Submission to Department of Planning, Housing and Infrastructure- **SSD-105396208**

Development Application: SSD-105396208

Address: 490 Chapel Road, Bankstown

Applicant: Health Administration Corporation

Figure 1: Proposed Site Plan

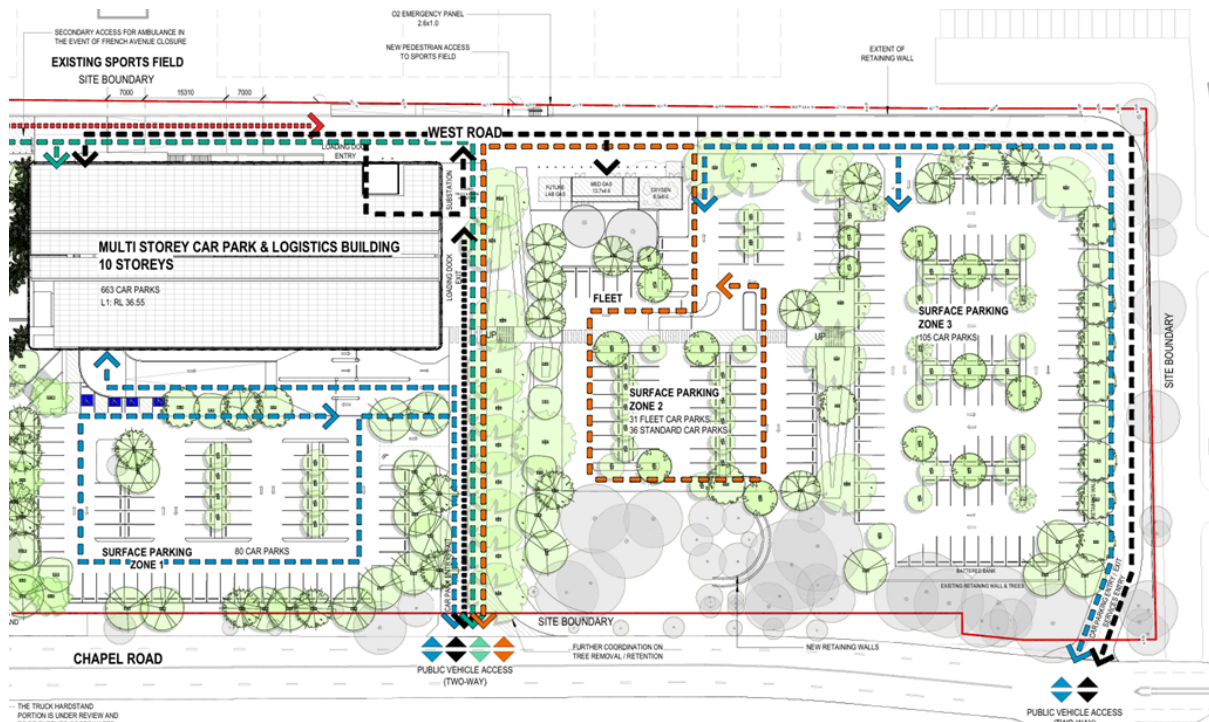
The proposed site plan indicates a new east-west link road (New Link Road) and pedestrian access point from Chapel Road to the playing field. The EIS notes in respect of the new link road that *'public vehicles will not be permitted beyond the three surface car park zones...'* This restriction is not supported. Vehicular access to the entrance of the playing pitches must be permitted where required for school operations, including emergency vehicles, staff access, parent and carer access, and maintenance of the fields. It is imperative that vehicular access is provided to the playing pitches, particularly in case of injury whereby emergency vehicles can get access onto the fields.

There does not seem to be any design prepared for pedestrian access along the West Road. Not designing for pedestrian access does not mean that pedestrians will not traverse the edge of the site. CAS & SCS request that segregated pedestrian access is provided along West Road so that hospital staff, patients, families, students and the general public who try to use this road can do so safely and segregated from the hospital traffic.

During engagement with the Health Infrastructure team, CAS provided advice that vehicular access to the Parish and LSCC land should be provided off the roundabout where the New Link Road meets the West Road. Access would be shared by the Parish and LSCC, and the number of vehicle movements, if development is approved on part of the playing fields, is estimated to be limited to less than 100 light vehicles a day.

CAS & SCS request that the design of the interchange between the New Link Road and West Road is designed to accommodate a roundabout and future access into the playing fields. This approach would safeguard the long-term strategic value of the land, avoid sterilising future development opportunities and ensure that the current proposal does not preclude reasonable and orderly future use of the site.
